June 30, 2015
Serial: MNS-15-026

Duke Energy Carolinas, LLC (Duke Energy)
McGuire Nuclear Station, Units 1 and 2
Docket Nos. 50-369 and 50-370
Renewed License Nos. NPF-9 and NPF-17

Subject: License Amendment Request for Temporary Changes to Technical
Specifications for Correction of an 'A' Train Nuclear Service Water System
(NSWS) Degraded Condition

Figure 6: NSWS Alignment During 14 Day Out of Service Window

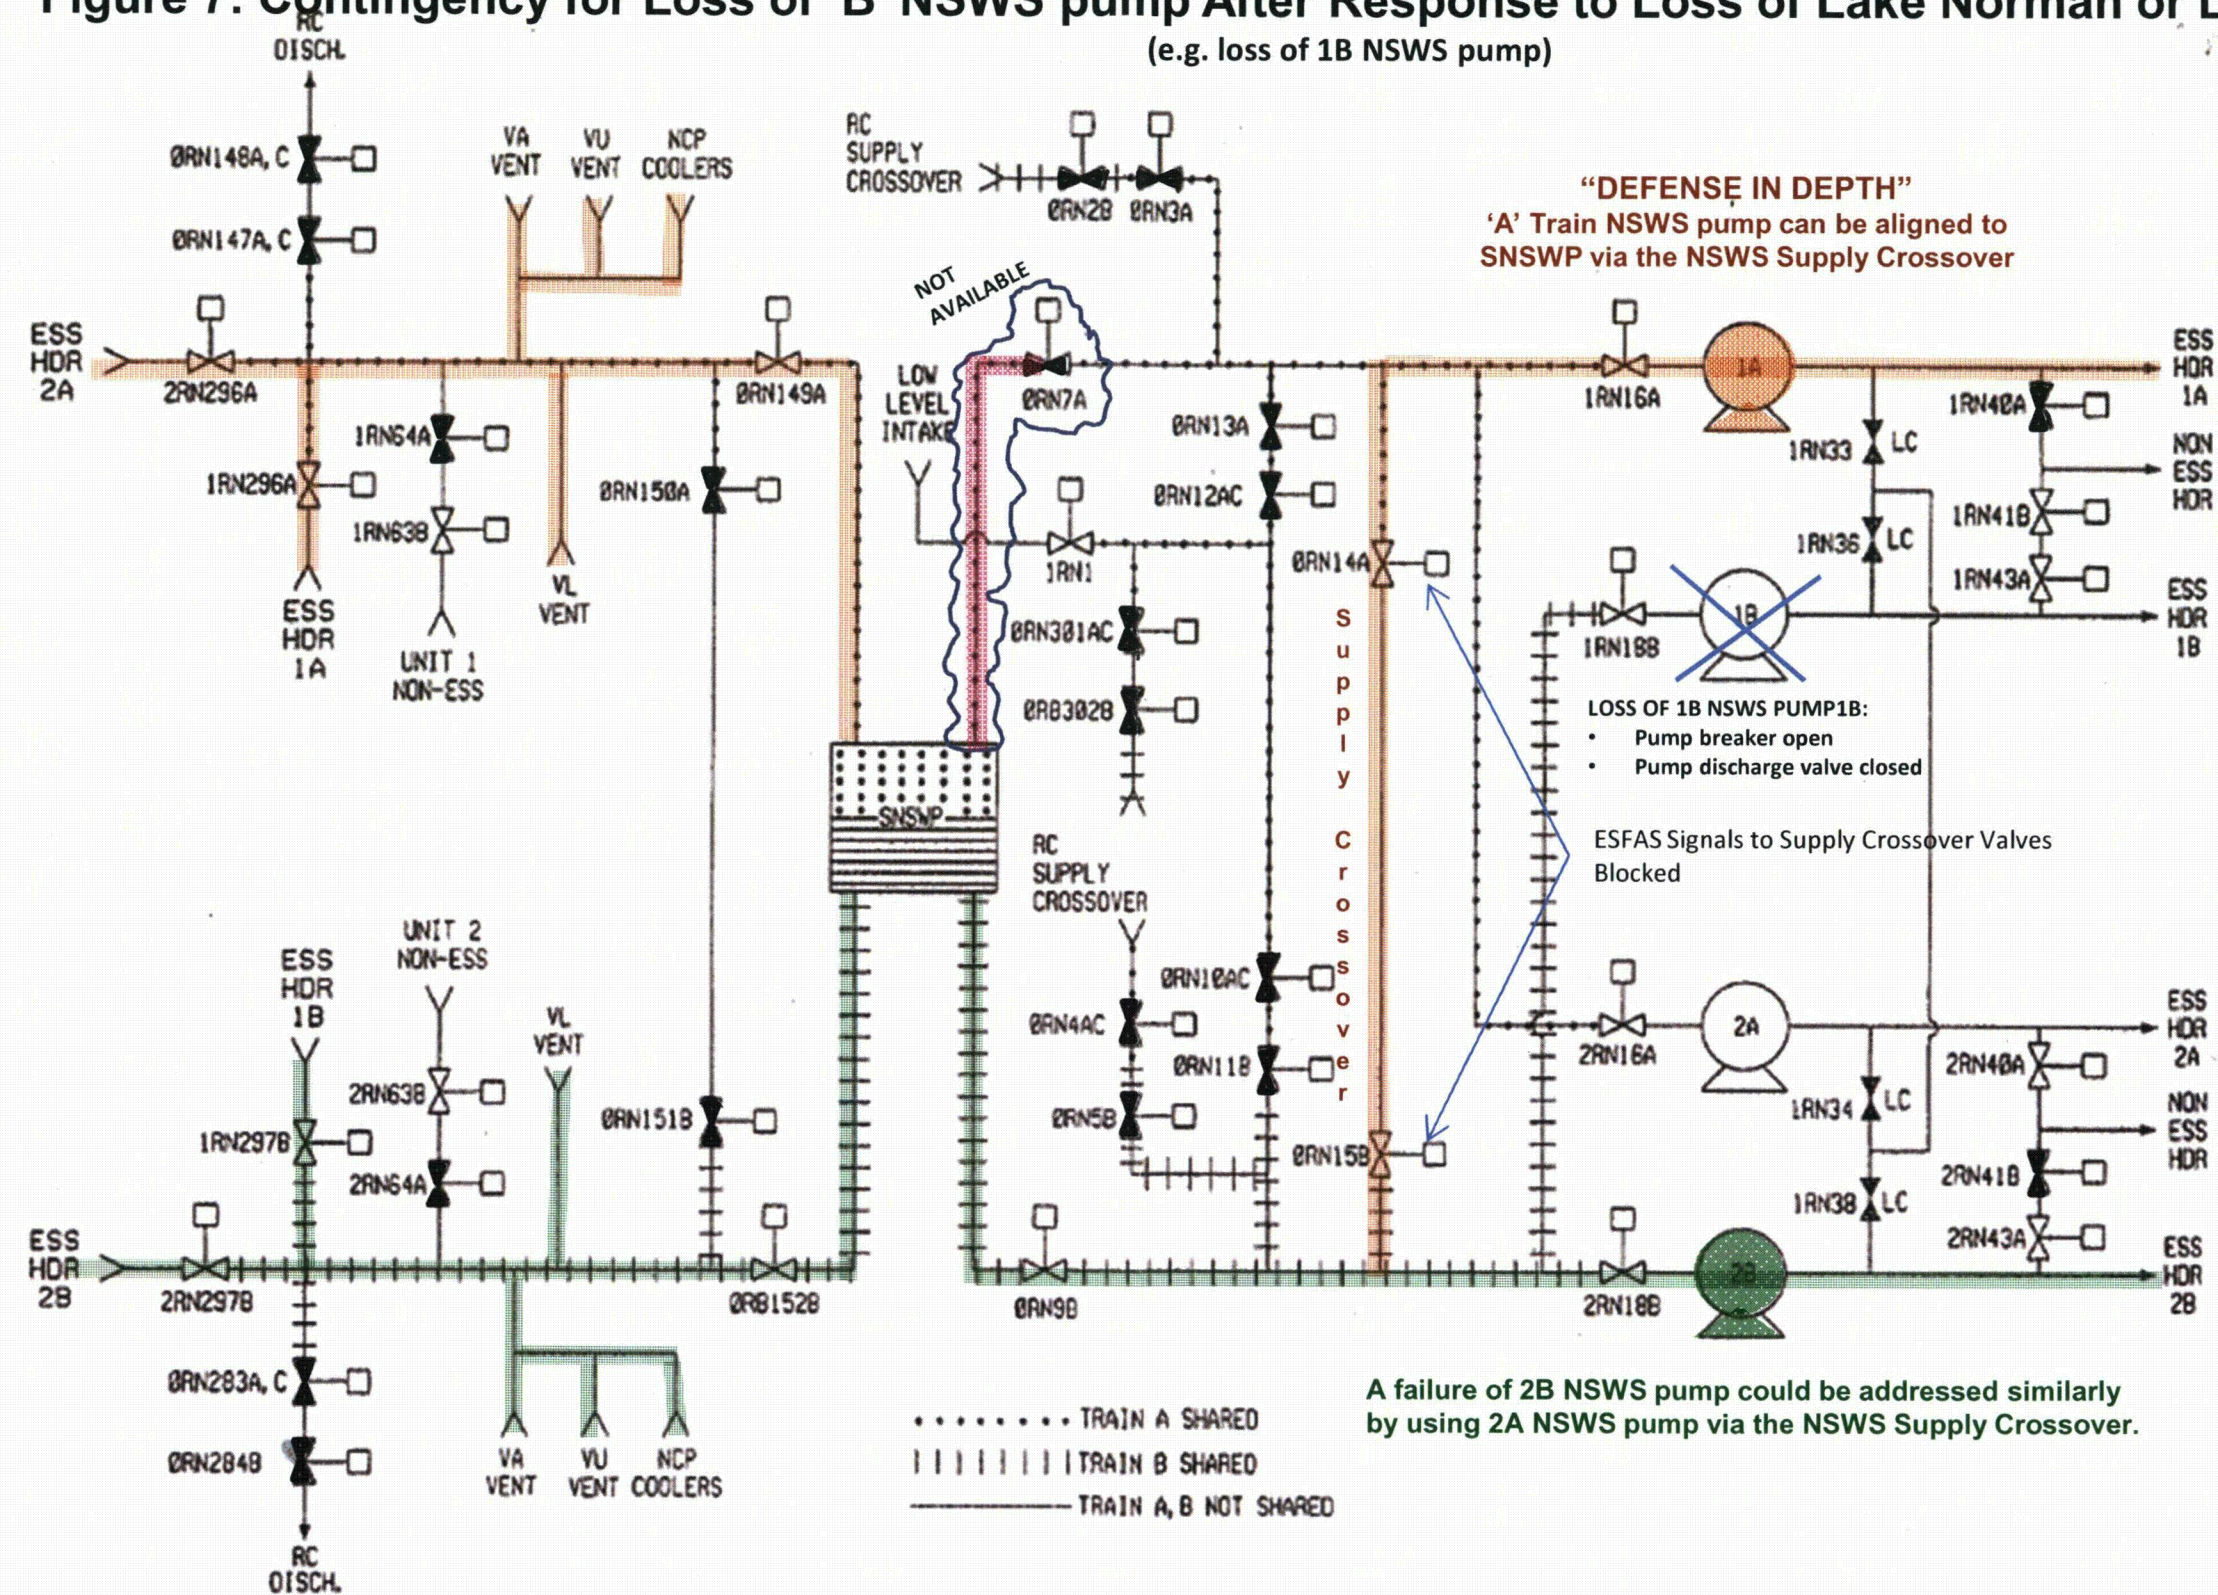
The pipe repair activity will require 'A' Train NSWWS be aligned to be Lake Norman until the system is ready for post maintenance testing (see Figure 6: NSWWS Alignment During 14 Day Out of Service Window, in Attachment 4). This is the normal and ESFAS alignment for 'A' Train NSWWS. The 'A Train' NSWWS supply from the SNSWP will be closed with power removed from the motor operated valve 0RN-7A (see Figure 5: Piping to Be Removed from Service during the Extended Completion Time, in Attachment 4). This will remove the capability to manually align the 'A' Train NSWWS to the SNSWP in response to a seismic event that results in damage to the supply piping from Lake Norman or the highly improbable loss of Lake Norman. If such an event should occur during the activities in the proposed amendment, 'B' Train NSWWS will supply all necessary needs to maintain the Ultimate Heat Sink Safety Function.

Figure 7: Contingency for Loss of 'B' NSWS pump After Response to Loss of Lake Norman or LLI
(e.g. loss of 1B NSWS pump)

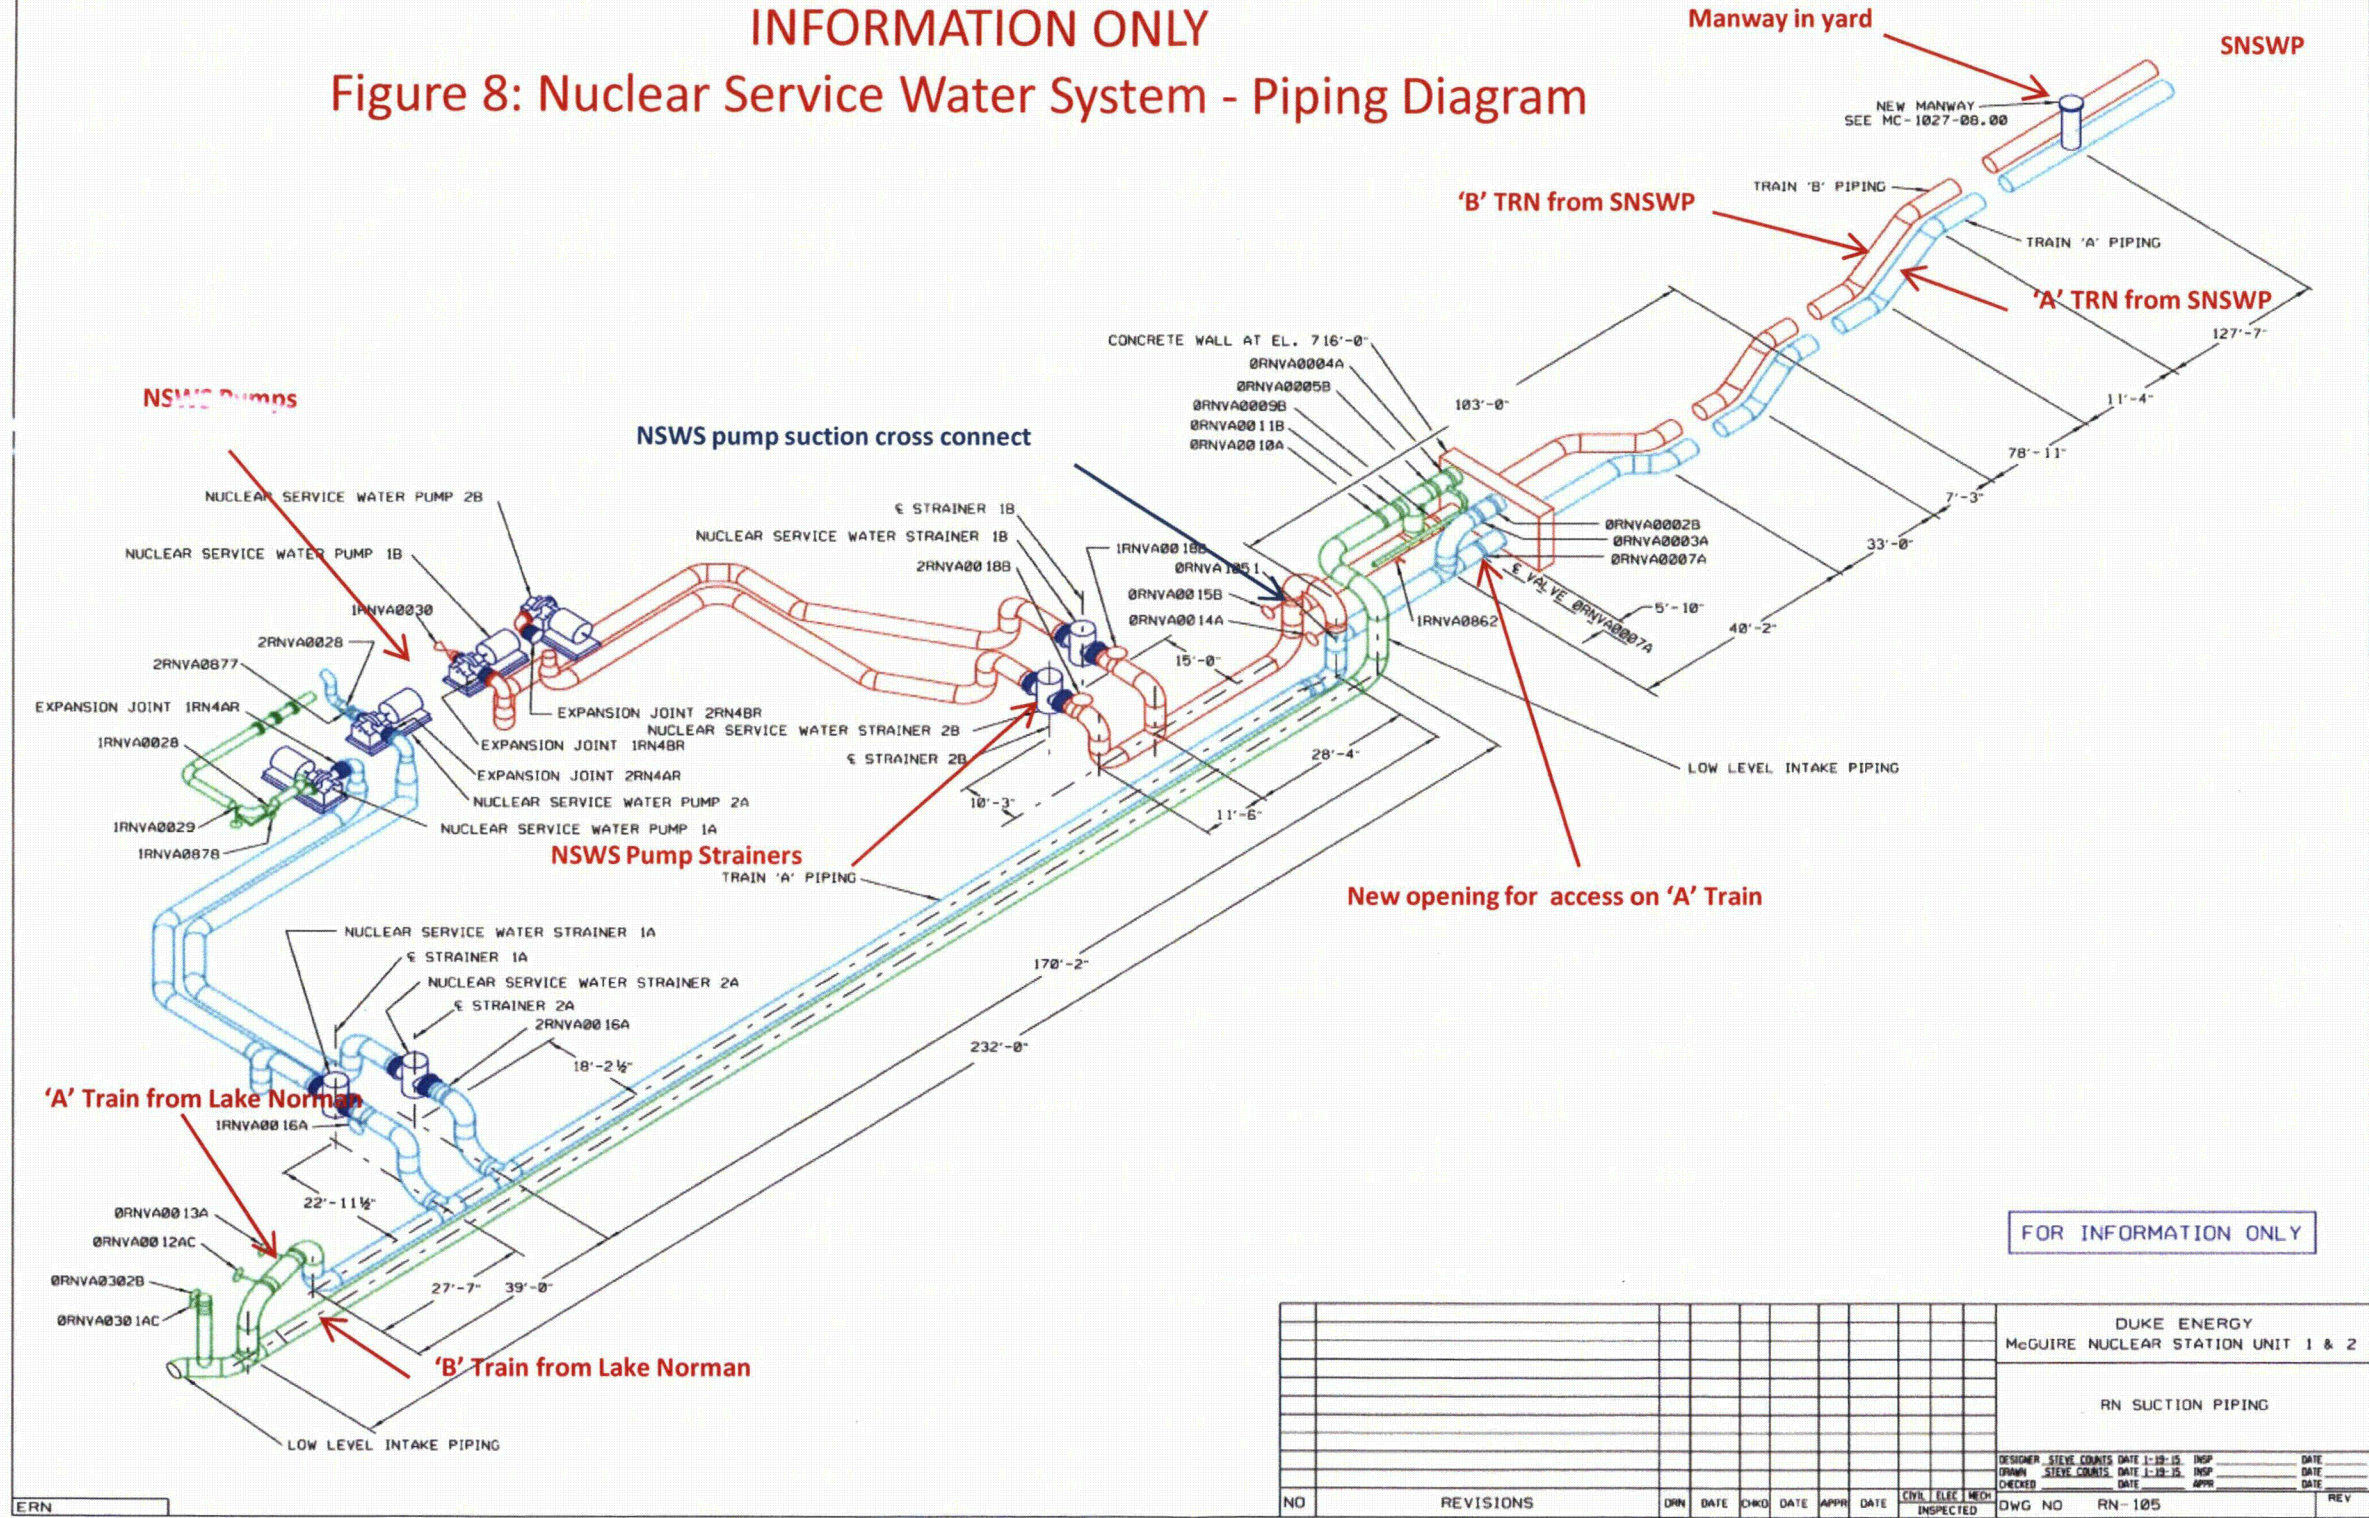
As stated above, one of the 'B' Train NSW pumps will be running and one of the 'A' Train NSW pumps will be running with both pump suctions aligned to the SNSWP through the "B" NSW supply pipe. The specific pumps will be dependent on which 'B' Train NSW pump fails (See Figure 7: "Contingency for Loss of 'B' NSW pump After Response to Loss of Lake Norman" which shows the alignment for a failure of 1B NSW pump).

The main supply crossover piping is normally isolated by motor operated isolation valves 0RN-14A ('A' Train) and 0RN-15B ('B' Train). Each valve receives an ESFAS signal from both units to close even though the valves are normally maintained closed. See Figure 6: NSW Alignment During 14 Day Out of Service Window in Attachment 4. Also see Figure 7: Contingency for Loss of 'B' NSW pump After Response to Loss of Lake Norman in Attachment 4 shows the contingency alignment for a failure of 1B NSW pump.

A failure of 2B NSWS pump could be addressed similarly by using 2A NSWS pump via the NSWS Supply Crossover.
